RE: Evergreen Plaza Parking Garage
Condition Evaluation Peer Review
Carl Walker, Inc. Project No. R1-2016-121

Carl Walker, Inc. has completed a peer review of the Structure Evaluation Engineers, Inc. (SSE) May 8, 2014 Condition Evaluation Report for the Evergreen Plaza Parking Garage located in Evergreen Park, Illinois. The attached letter includes a discussion of our evaluation findings, repair recommendations, and cost opinion.

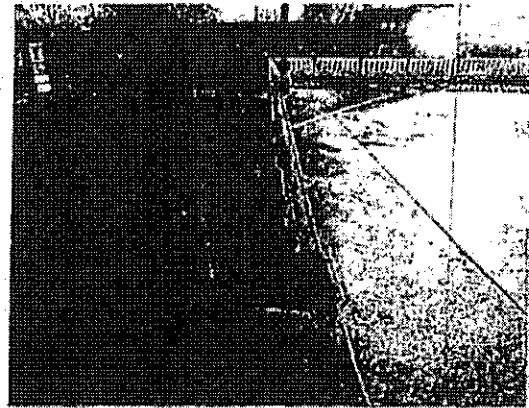
We worked with building staff to locate original design drawings for the parking garage. This included searching through two filing cabinets in the building attic that contained multiple copies of the original construction blue prints. During our search, we identified at least two sets of building drawings that had the garage drawings removed and not available. We found a third set of structural drawings that included the garage floors. The drawings were prepared by Bartholomed and Hansen Architects and dated 05-23-1968. The garage was shown on Draws S1, S2, S2A and S3. Unfortunately, we found these garage drawings to be inconsistent with the as-built construction. The drawings show joists spanning in the east-west direction supported on north-south spanning post-tensioned beams. This is opposite of the as-built construction where the joists span in the north-south direction supported by east-west spanning beams. We also noted that the joist schedule shows the original design joists being 10" wide by 20" deep at 2'-6" on-center, compared to the as-built joists being 5" wide by 12" deep at 2'-10" on center.

The design drawings would have resulted in a structure with a higher load carrying capacity than the as-constructed structure. A note on the original structural drawings indicate that the design live load of the roof level was to be 100 psf, versus 75 psf to 80 psf that was typical of parking structures of this era (50 psf for vehicles and 25 to 30 psf snow). It is possible that after these drawings were prepared, the design was changed to reduce the allowable live load.

Based on our review, we believe the available original drawings are not accurate or cannot be relied upon for anything more than overall site dimensions and general layout.

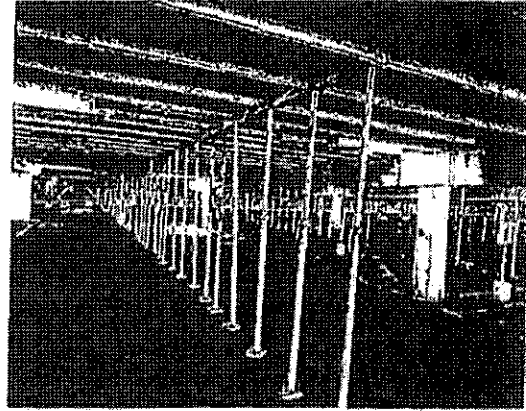
The roof level floor exhibited several delaminations and one full depth hole. We also noted widespread cracking in the floor surface.

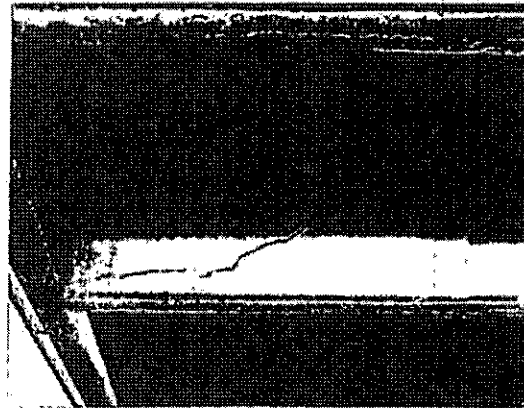
At the lower level, post shores were installed at midspan beneath most of the concrete joists.

Vertical through cracks were present in a majority of concrete joists. We estimate that 60% to 80% of the concrete joists exhibit at least one crack ranging in width from 0.010 inches to as wide as 0.375". The cracks were typically located at the ends of the joists and are consistent with a shear over-stress.

Shear failures can be sudden and without warning. Additional temporary shoring to support the joists at the cracked ends is required to continue safe operation of the upper level. (We understand that after our visit, SSE and Zera Construction were engaged to design and install additional shoring.)

1. The joists are exhibiting cracking consistent with a shear failure due to overloading. Shear failure can be sudden and without warning. Additional temporary shoring is required in order to maintain safe usage of the upper level garage.
